Re: Florida Power & Light Company
Proposed Turkey Point Units 6 and 7
Docket Nos. 52-040 and 52-041
Response to NRC Request for Additional Information Letter No. 64 (eRAI 6544)
Related to SRP Section 03.05.03 – Barrier Design Procedures

Proposed Turkey Point Units 6 and 7
Docket Nos. 52-040 and 52-041
FPL Response to NRC RAI No. 03.05.03-34 (eRAI 6544)
L-2012-352 Attachment Page 1 of 7

NRC RAI Number: 03.05.03-34 (eRAI 6544)

The plot of this forcing function considering horizontal impact is shown in Figure 1. The frontal impact is 6.6 feet x 4.3 feet as per Regulatory Guide 1.221, Revision 0, October 2011.

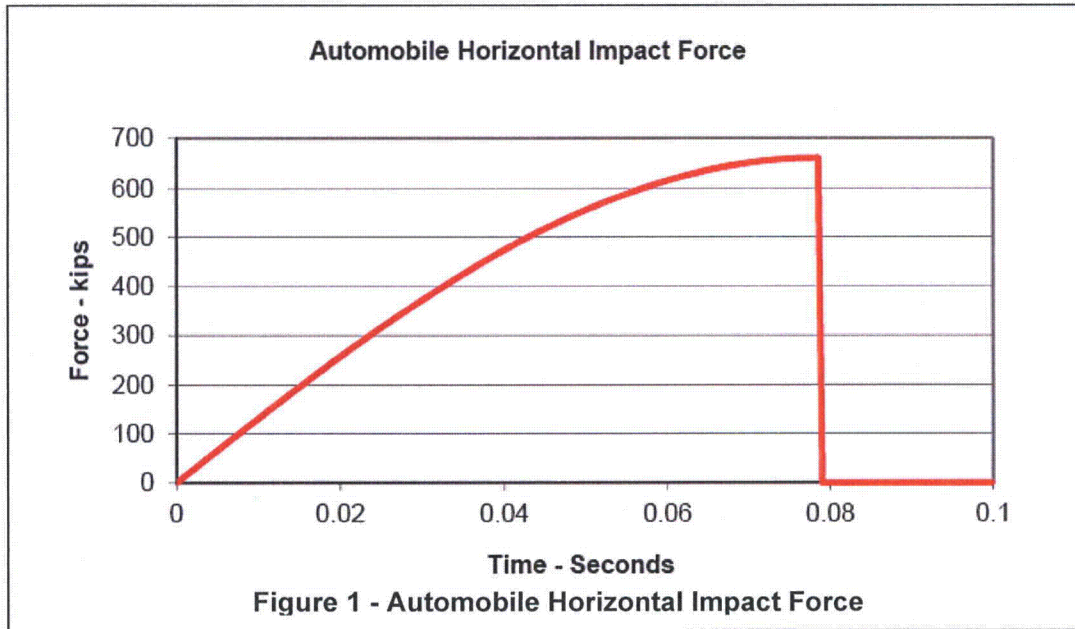
1 - The staff request clarification on the use of the hurricane wind and missile impact load as it relates to Section 3.8.4.3.1.3 of the AP1000 DCD, where extreme environmental loads are defined. Given that the information in RG 1.221 indicates that the Turkey Point site may be prone to hurricane missile velocities higher than tornado missile velocities, structural demands from tornado missile loads may not bound those from hurricane missile loads. The staff requests the applicant to explain how the hurricane wind and missile impact loads (from the automobile missile) are considered (or not) as extreme environmental loads described in the AP1000 DCD. If hurricane loads (wind and missiles) are not considered in the structural analysis, provide a technical basis for not considering the hurricane wind and missile loads.

The forcing function for the automobile missile is defined in Reference 1. The forcing function associated with the impact of the automobile onto the structure is defined as a quarter sine wave. The basis of this formulation is that "the automobile is considered as a deformable missile and the structure as a rigid target." This formulation is given below:

$$F_t = 0.625 V_c W \sin (20t) \quad 0 < t \leq 0.0785 \text{ sec}$$

- V_c = impact velocity during impact (fps)
- V_c = 264 fps for horizontal impact based on the horizontal velocity of 180 mph
- W = weight of automobile = 4000 lbs
- F_t = 660 Sin (20t), kips for horizontal impact
- t = time (sec)
